Outermost Inn Modification DRI 336-M2

Martha's Vineyard Commission
Public Hearing
Jan. 12, 2023

Modification review

PROPOSED PARTIAL NORTH ELEVATION

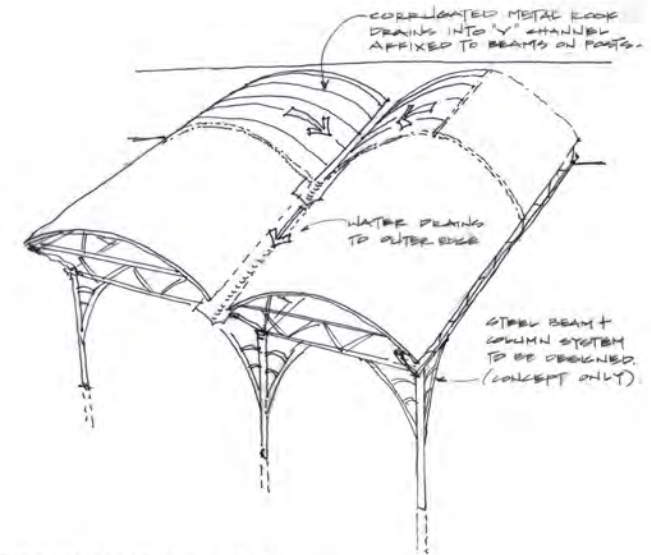
- Construct a permanent canopy with metal frame and corrugated metal roof, and expanded concrete pad, to replace a temporary 30'x40' stretch tent over an outdoor seating area.
- The permanent awning would require expanding the existing concrete pad by about 480 ft².
- The outdoor seating area and tent were added near the beginning of the Covid-19 pandemic in 2020 to account for safety protocols and provide shade.
- The applicant has stated that outdoor dining has remained popular even after the protocols were lifted, and that a permanent covering would require less maintenance, including in high winds.

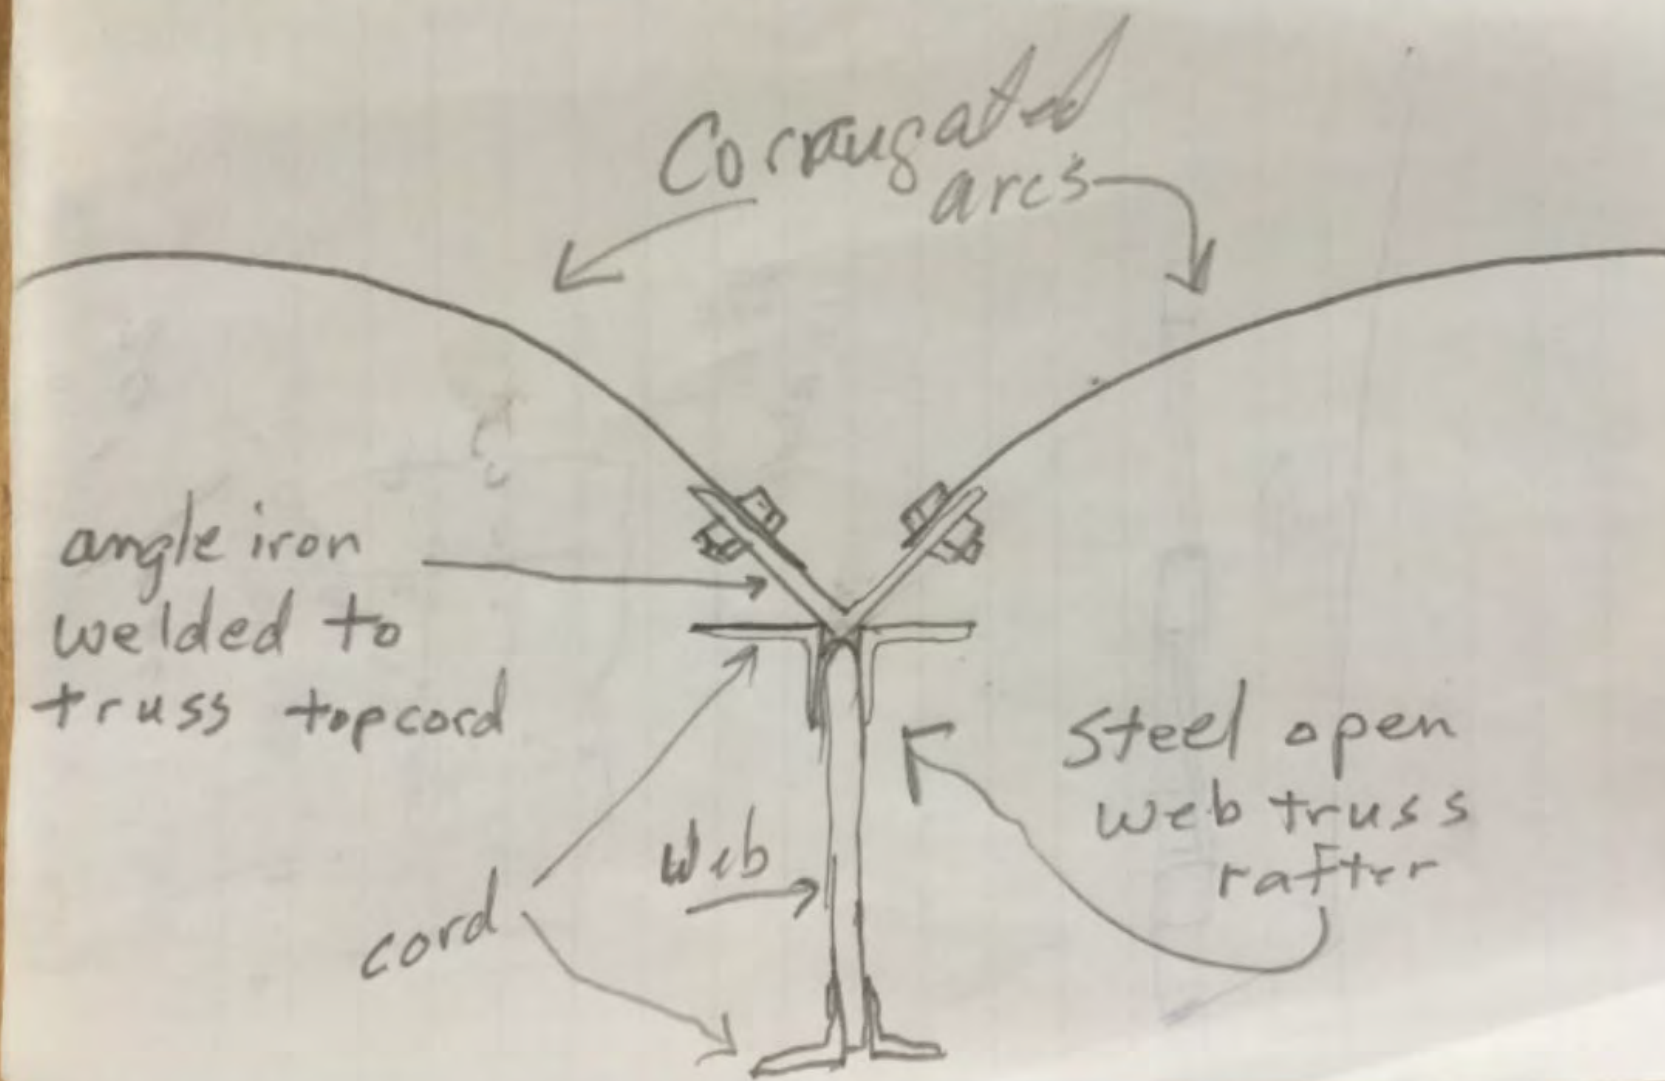
- The proposed structure would be connected to the existing building and would include V-shaped channels in the canopy that direct runoff away from the structure.
- A formal drainage plan is still pending.

PROPOSED PARTIAL NORTH ELEVATION

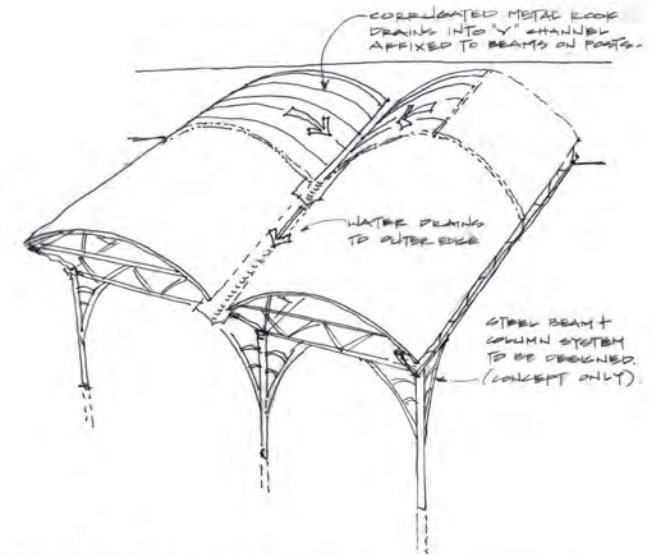
- According to the applicant, the proposed awning structure “is designed to be light in appearance, utilizing arched corrugated steel roofing to fashion a strong awning without a conventional, bulky, rafter system. We hope to achieve an open feel similar to the roof structure employed at the Tabernacle with open web steel trusses, arched bays of corrugated steel and fine steel uprights as vertical support.”
- Elevation drawings have been provided.
